ENVIRONMENTAL REVIEW TEAM REPORT

HIGHWOOD FARMS
THOMASTON, CONNECTICUT

HIGHWOOD FARMS
THOMASTON, CONNECTICUT
MAY 1981

ENVIRONMENTAL REVIEW TEAM REPORT
ON
HIGHWOOD FARMS - THOMASTON, CT

FIGURE I.
SIMPLIFIED SITE PLAN

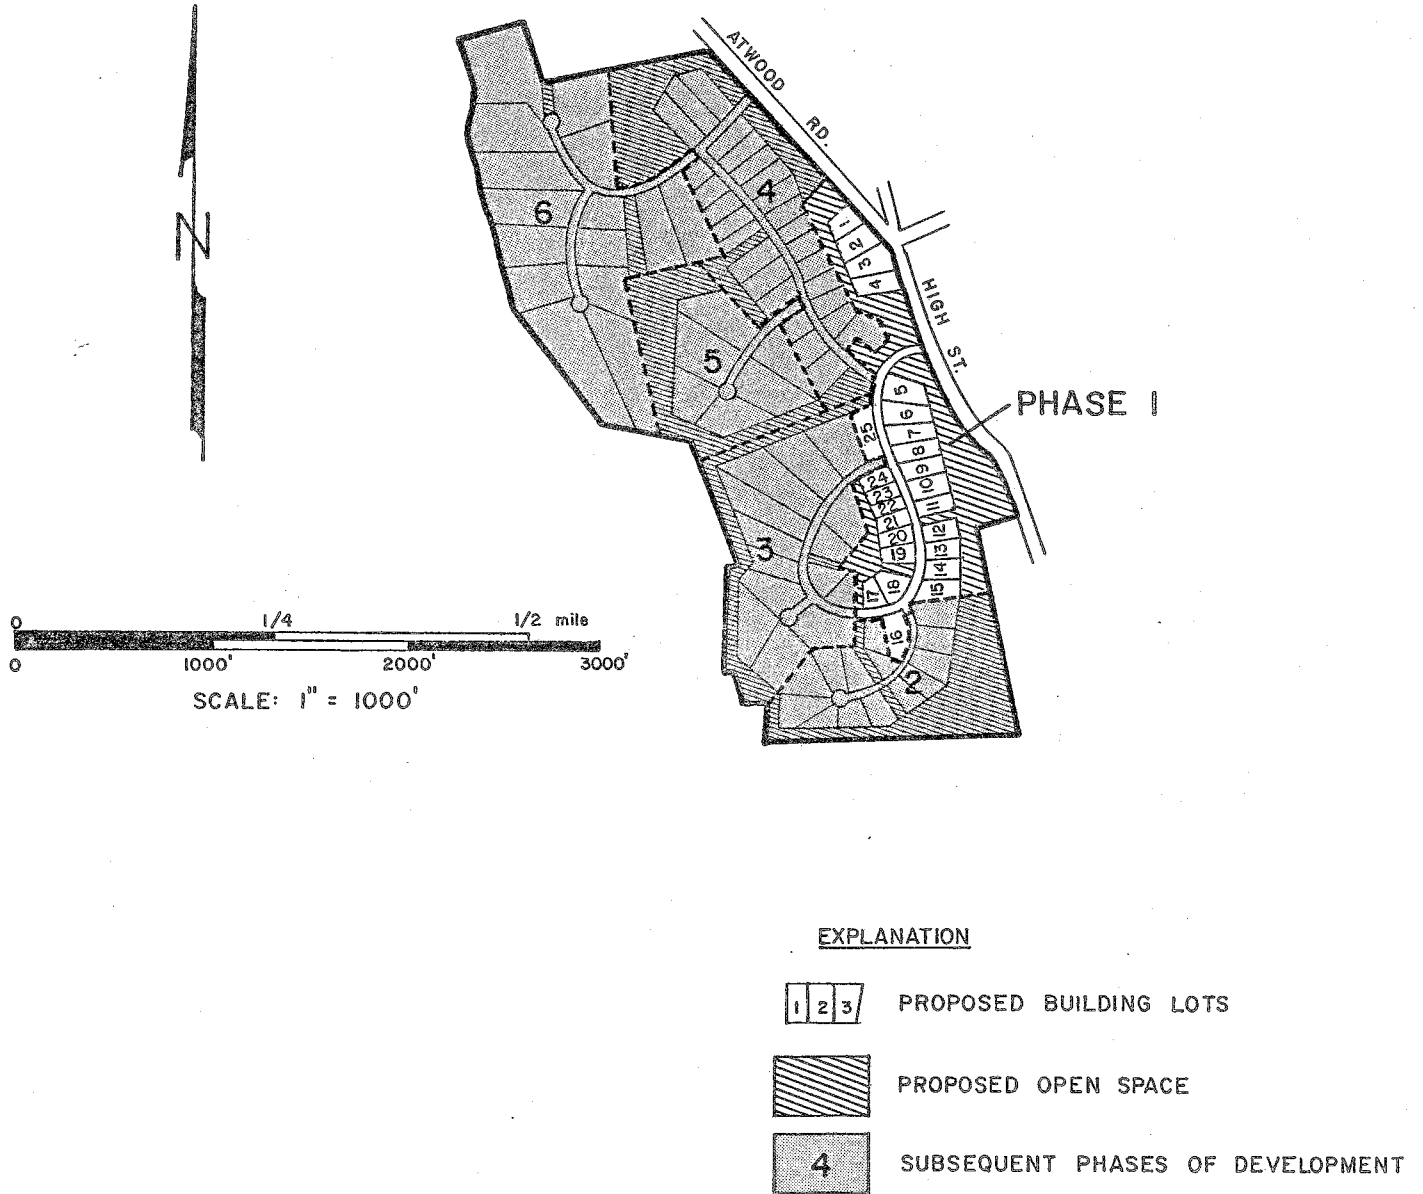
Parts of lots #1-4 and #25 are mapped as wetland areas. Care should be taken on filling in the wetland portion of these lots. (No actual house locations are shown on the plan.)

The access road from High Street is planned to cross + 100 lineal feet of wetland. With proper designing of the road and culvert, the effect on the wetland system should be minimal. The remaining portion of the road within the Phase I area seems to be well planned crossing a minimum of contours in its traverse.

The northernmost detention pond shown on the plan should be shortened on the north side (a reasonable cutoff point seems to be in the proximity of the 800 contour line).

The westernmost pond shown on the plan may not be feasible due to the nature of the soils in the area. It appears that a culvert crossing from this area to across the street into another planned detention pond will suffice.

The watershed for the northernmost pond is + 12 acres. For the best detention value, a principal spillway should be designed for a two year storm, and emergency spillway for 25-50 year storm.

FIGURE 4.
VEGETATION TYPE MAP

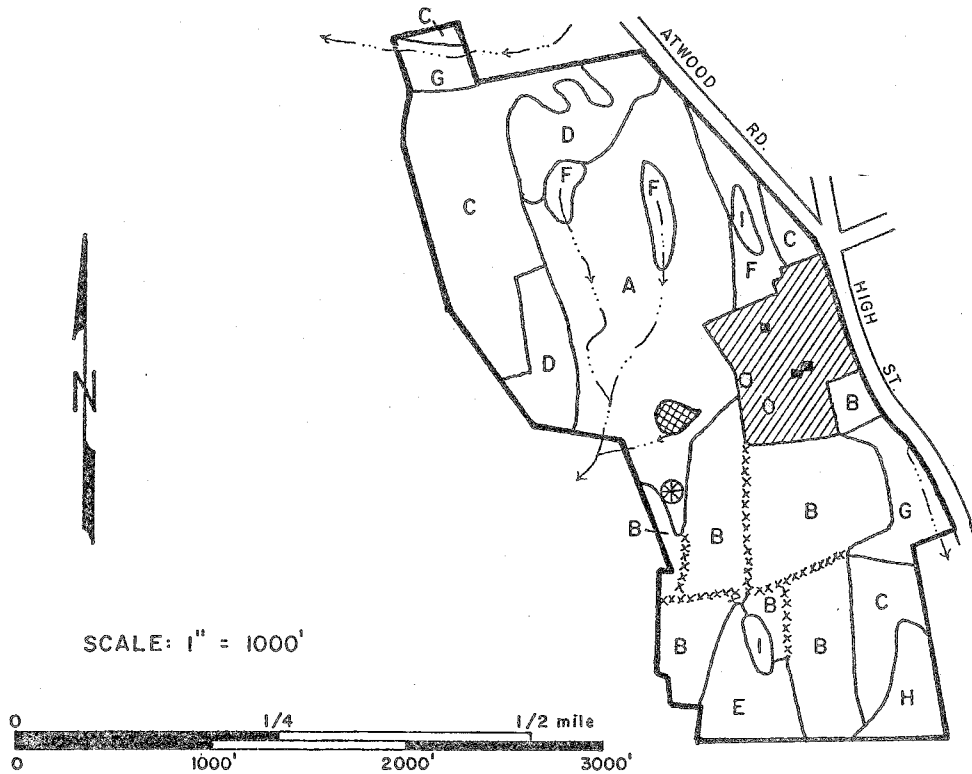
The trees which are present along the fences which run through the open fields (Vegetation Type B) add considerable character to this tract of land. If it is at all possible these fence rows should be incorporated into the overall site plan for this property.

The trees in the hardwood swamp (vegetation type F) and the mixed hardwood stand Type G are also declining in health. Light thinnings in these stands would help to improve the stability of the residual trees in time. These thinnings should remove no more than one fourth of the total volume which is present. They should be focused on removing unhealthy, poor quality, damaged trees and trees which are directly competing with healthy trees. These thinnings will produce approximately 5 cords of fuelwood per acre.

If the open field areas (vegetation type B) are not to be developed for several years it would be desirable to establish trees. These fields could be planted with a random mixture of eastern white pine, european larch and eastern hemlock, spaced between 10 and 15 feet apart. As this area is developed, the trees which need to be removed could be transplanted to other areas. These trees
